05.1-14

## TECHNICAL BULLETIN

### Engine Misfire/Starting Difficulty – Harness Connector Modification

MODEL 1995-96 MY  
Sedan (4.0L) Range  
VIN  
720001-771156

ILLUSTRATION 1

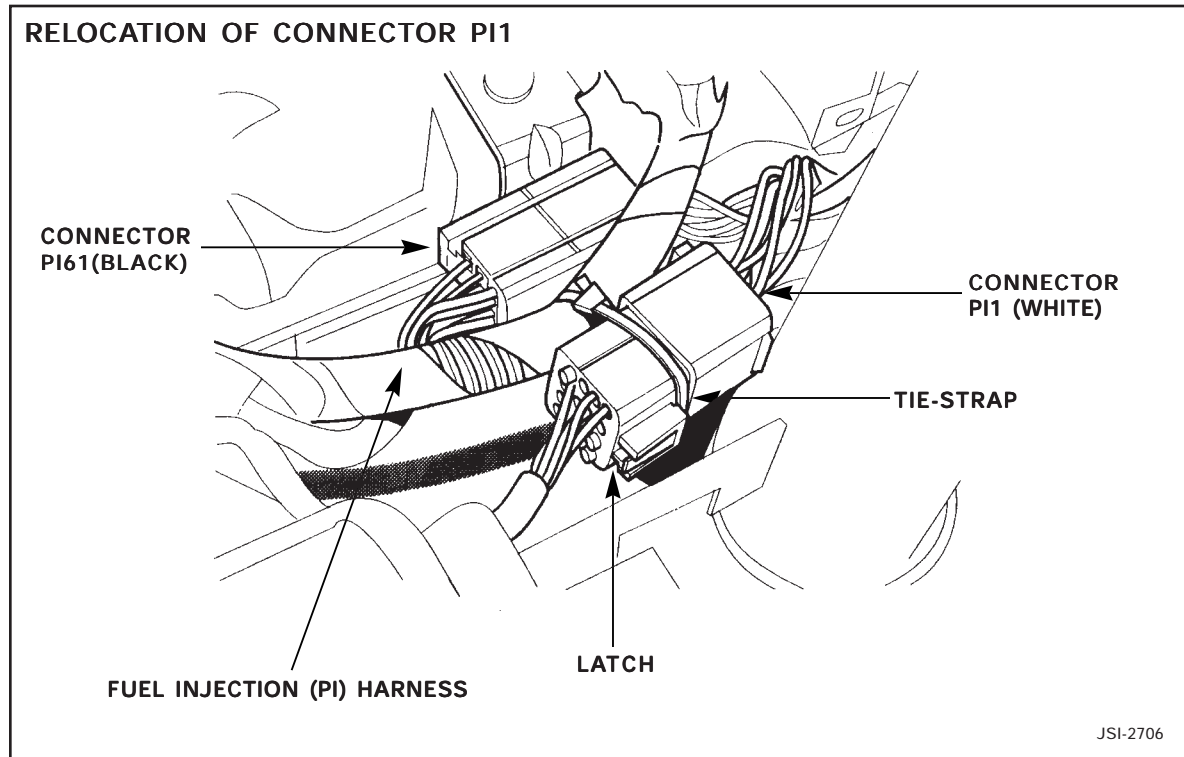
The connector was modified beginning with VIN 771157. The modification can be made on earlier vehicles if corrosion is found.

In case of a customer complaint of engine misfire/starting difficulty on a 1995-96 MY Sedan Range vehicles within the above VIN range, check for the entry of water into the white harness connector (PI1), located rearward of the right side headlamp. If corrosion is found, relocate the connector as described on the next page, in addition to any other repairs made.

1. Do not return connector PI1 to its original location in the bracket below the black connector PI61.
2. Secure the white connector PI1 (Illustration 1) to the fuel injection (PI) harness using a tie-strap so it is adjacent to the black connector PI61. Position the latch outwards as shown in Illustration 1.
